# CITY OF ATLANTA

## MEMORANDUM

**TO:** Atlanta Urban Design Commission  
**FROM:** Matt Adams, Executive Director  
**ADDRESS:** 1163 Wilmington Avenue  
**APPLICATION:** CA2-23-323  
**MEETING DATE:** December 13, 2023, deferred since October 11, 2023

**TO:** Atlanta Urban Design Commission  
**FROM:** Matt Adams, Executive Director  
**ADDRESS:** 378 Grant Park Place SE  
**APPLICATION:** CA2-23-346  
**MEETING DATE:** January 24, 2024

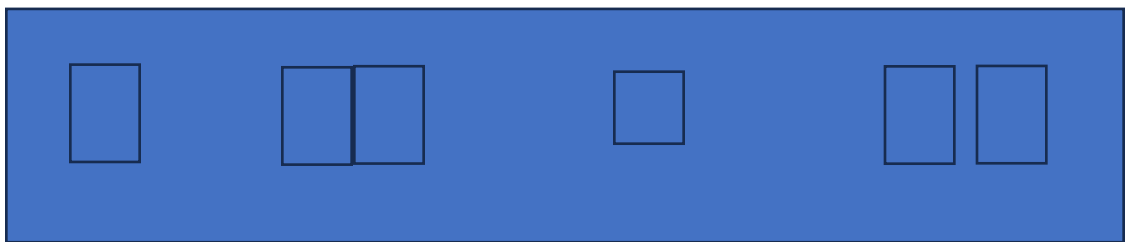
It appears that all windows on the house have been replaced without a permit or approval. Many of these windows appear to be significantly smaller than the windows which were existing. Sec. 16-20G.006 (3) (a) Architecturally significant windows and doors, including details, trimwork, and framing, shall be retained." Further, "(b)Original window and door openings shall not be blocked or enclosed, in whole or in part." Further, "(c) Replacement windows and doors shall be permitted only when originals cannot be rehabilitated. Replacement windows and doors shall match the original in style, materials, shape and size, with no more than a one-inch width or height difference from the original size." No specifications for the windows have been submitted, no justification has been provided for the replacement of windows, including photos of their condition prior to removal. The Applicant proposes reconfiguration of windows on the left, right, and rear elevations, though based on photographs taken by the code enforcement team this change was already made. Staff is confused by the proposed window reconfiguration as it appears that the internal floor plan is not changing. Sec. 16-20G.006(e) states, "the replacement and reconfiguration of windows on the side elevations to accommodate kitchens and bathrooms is permitted." It appears that the interior layout remains the same, and the removal of windows was not appropriate. The Applicant will submit specifications for the unpermitted windows. The Applicant will restore the original window configuration and size, with no more than an inch difference in size.

- 6.) **The Applicant will submit specifications for the unpermitted windows. The Applicant has submitted specifications for the windows which were installed. Staff finds that they do not meet the requirements of Sec. 16-20G.006 (3)(c). On the most recent set of plans the description provided (which refers to all windows as wood, does not match the proposed which clearly states that they are constructed of PVC. In the West End Historic District per Se. 16-20G.006 (3)(c), "Replacement windows and doors shall be permitted only when originals cannot be rehabilitated. Replacement windows and doors shall match the original in style, materials, shape, and size, with no more than a one-inch width or height difference from the original size. The use of simulated divided lite windows is permitted." This requires that the replacement windows must be wood, with no more than an inch difference in size. No vinyl windows are permitted.**

- 7.) **The Applicant will restore the original window configuration and size, with no more than an inch difference in size. The Applicant must submit new specifications for appropriate windows which match the originals in material, design, and size, with no more than an inch difference in size. Staff notes in particular that the windows on the right elevation have been enclosed, rather than reconfigured to accommodate a kitchen and a bathroom. This is**
